# MONOGRAM SYSTEMS

## SERVICE BULLETIN

NO: 871500-25-2146

GLOBAL EXPRESS CREW SEATS – FORE/AFT ADJUSTMENT CABLE STOP

PRE/POST-SERVICE BULLETIN CONDITION  
FIGURE 1 (SHEET 2 OF 3)

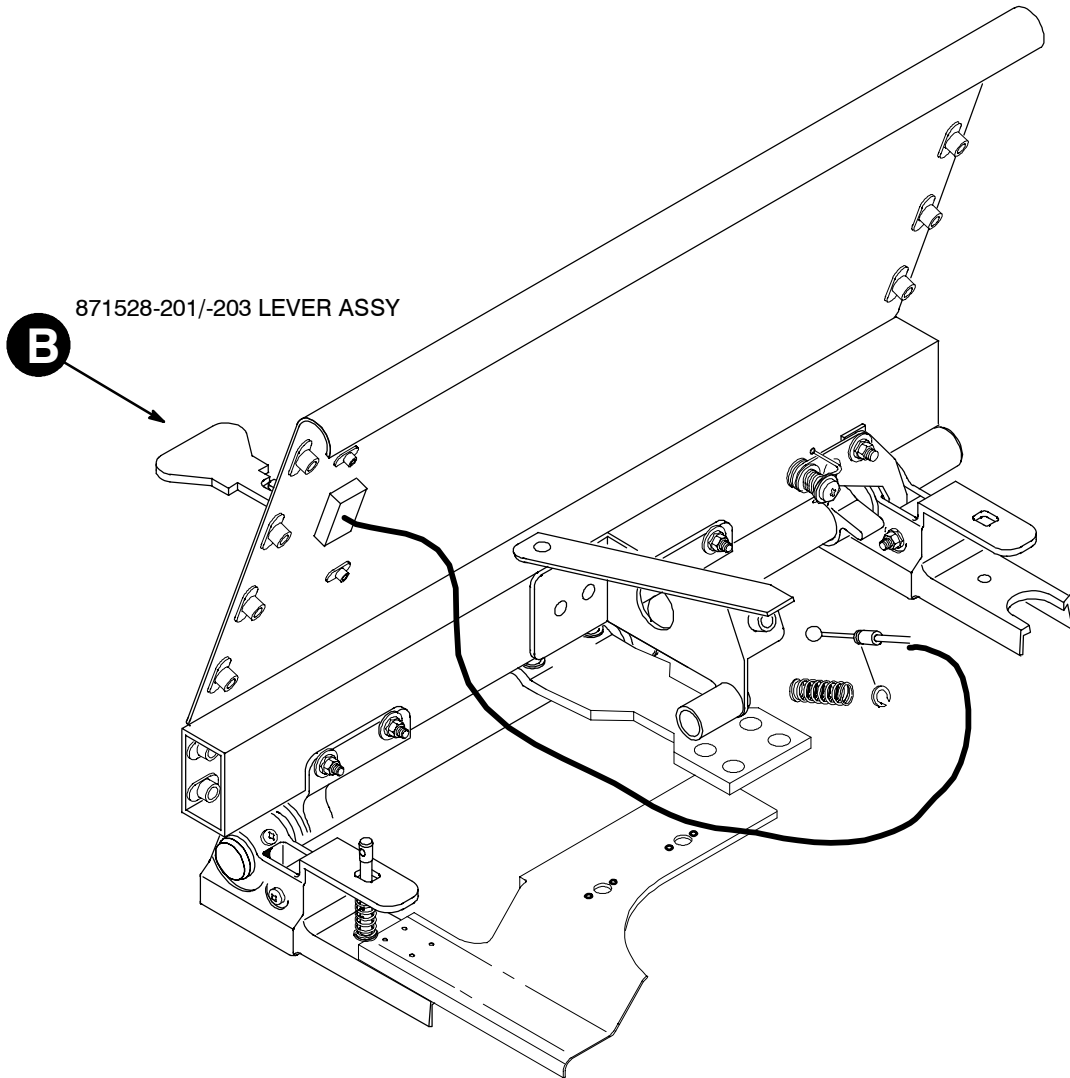
On both the Pilot/Co-Pilot Seats the service bulletin attaches a stop handle to the lever assembly on the fore/aft control installation. The SP Kits 120SP017 contains all the parts necessary to complete this job. (Refer to Table 1 for effectivity).

- (1) Refer to Figure 1.
- (2) On the 871500-602/-604/-604-001/-604-003/-604-004/-606/-606-001/-608 Pilot Seat Assemblies remove and retain the NAS388-8-8 Screw from the 871528-201/-203 Lever Assembly on the 871528-401/-403/-405 Fore/Aft Adjustment and Control Installation.
- (3) On the 871500-603/-605/-605-002/-605-003/-605-004/-607/-607-001/-609 Co-Pilot Seat Assemblies remove and retain the NAS388-8-8 Screw from the 871528-201/-203 Lever Assembly on the 871528-402/-404/-406 Fore/Aft Adjustment and Control Installation.

- (1) Refer to Figure 1.
- (2) On the 871500-602/-604/-604-001/-604-003/-604-004/-606/-606-001/-608 Pilot Seat Assemblies insert the new 871832 Handle-Fore/Aft Control, Stop into the 871528-201/-203 Lever Assembly, reinstall the existing NAS388-8-8 Screw.
- (3) On the 871500-603/-605/-605-002/-605-003/-605-004/-607/-607-001/-609 Co-Pilot Seat Assemblies insert the new 871832 Handle-Fore/Aft Control, Stop into the 871528-201/-203 Lever Assembly, reinstall the existing NAS388-8-8 Screw.
